**PRODUCT: N MALE CRIMP, STRAIGHT, 50 OHM, FOR AIRCELL 5, LMR-200**  
**PRODUCT CODE: E3701, Paratronic Oy**

Title	Value
Drawing date	30.4.2022
Version	B
Website	www.paratronic.fi

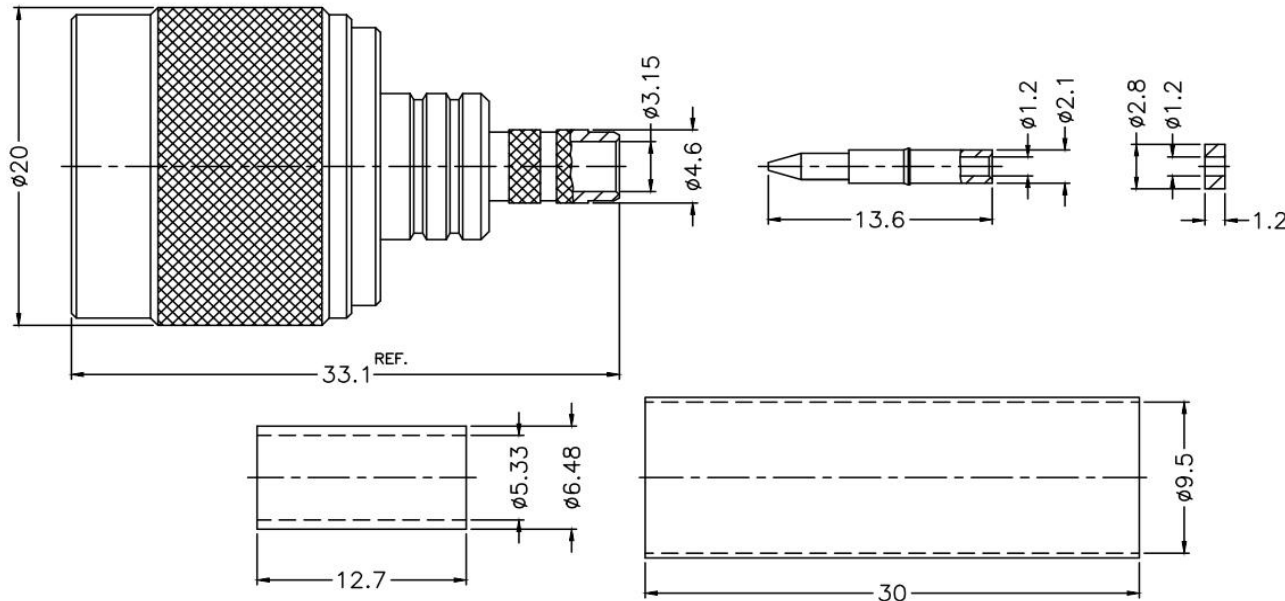
Version A > B, from batch W49/21, added a locking barb to pin.
